TECHNICAL MEMORANDUM

RE: 718460 The Caravela Apartments
SS Union Street (fka 278 Union St.)
Plot 46, Lots 18 & 21

DATE: September 27, 2021

This memo has been prepared to respond to a memorandum issued by Jamie Ponte, Department of Infrastructure (DPI), dated August 10, 2021.

FIGURE 15: Illustration of Gasoline, Oil and Sand Separator

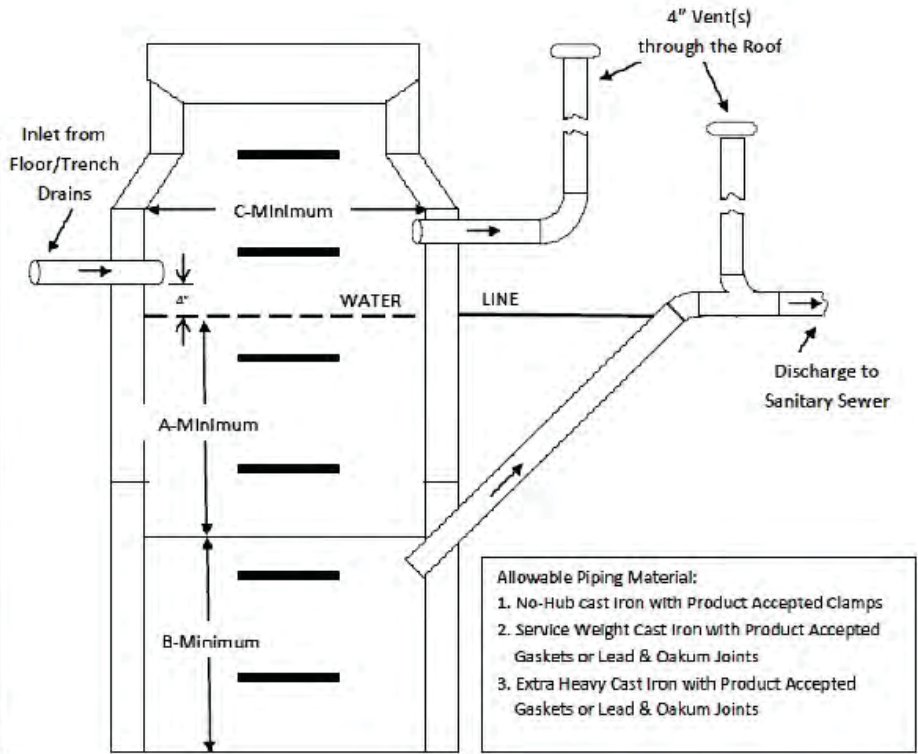
Comment 5 – The gasoline, oil and sand separator is proposed to accept accidental non-stormwater discharges from within the garage. Separators are required to be connected to the sanitary sewer as indicated in the Massachusetts State Plumbing code 248 CMR section 10.09 and 10.22 – Figure 15 (attached).
